TACOMA WATER DIVISION

Report Date: October 16, 2013

DOH System ID	86800 N	Survey Dates	8/9/13 – 8/12/13
System Type	Group A Community	Operating Permit	Green
Surveyor	John Ryding

Subject: Tacoma Water Division, City of; ID #86800
Pierce County
2016 Routine Surface Water Treatment Plant Sanitary Survey

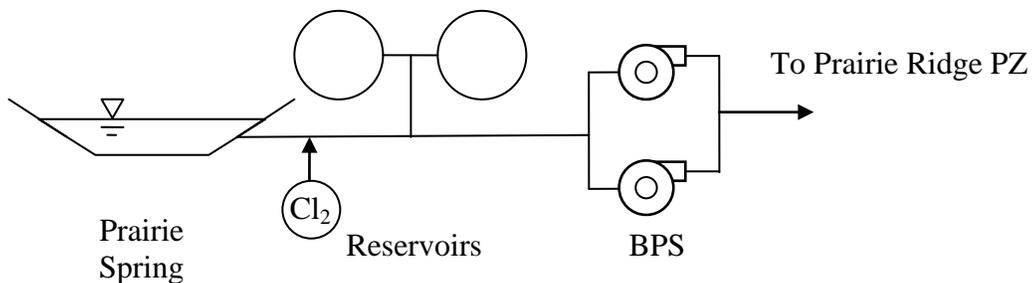
- There were unprotected openings into the pump wetwell between the cistern lid and the cistern itself (pictured at left). These openings have since been eliminated by the time of the report.

- *There was an inadequate air gap between the pump cistern overflow and the receiving creek (pictured at right).*

Significant Deficiency	Description of Deficiency	Planned Solution	Planned Completion Date
Well 3A Blow off Discharge Air Gap	The existing air gap on the blow off line does not meet minimum air gap requirements of 2x pipe diameter.	The existing blow off will be modified to meet the required 2x pipe diameter air gap above the concrete discharge floor.	Estimated completion 1st Quarter 2014
Well 10C Blow off Discharge Air Gap	The existing air gap on the blow off line does not meet the 2x pipe diameter above the high water level in the discharge basin.	The existing blow off will be modified to meet the required 2x pipe diameter air gap above the high water level of the drainage basin.	Estimated completion 1st Quarter 2014
Gravity Wells Blow off Discharge Air Gap	The existing air gap on the blow off line does not meet the 2x pipe diameter above the high water level in the discharge basin.	The existing two blow offs from both GPL wells will be raised to meet the minimum 2x pipe diameter air gap above the high water level of the drainage basin.	Estimated completion 1st Quarter 2014

Backwash Storage Tank

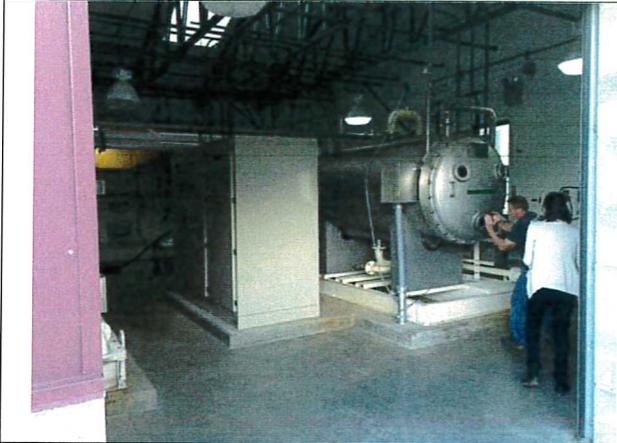
The clearwell vents were protected with a fine mesh screen. It was difficult to determine whether there was a fine mesh screen on the 10 MGal Backwash Storage Tank from the photographs provided. **Verify that the 10 MGal tank vents are protected with a fine mesh screen.**

- Verify the 10MG tank vents are protected with fine mesh screen.
We have, and attached please find a photograph labeled NF Tank.
- All alarms should be tested at least once a year.
The alarms we identified during our conversation and you noted on the report are on a quarterly schedule. The remaining approximately 3000 are not yet on a schedule to test annually. I will continue to work towards an effective method to test and our priority will remain those that actually effect physical functions of the plant (such as shutting down a system like ozone leak). In the meantime we will begin to mark block 39 of the SWTR Summary report as "Yes" as the critical alarms will be tested.
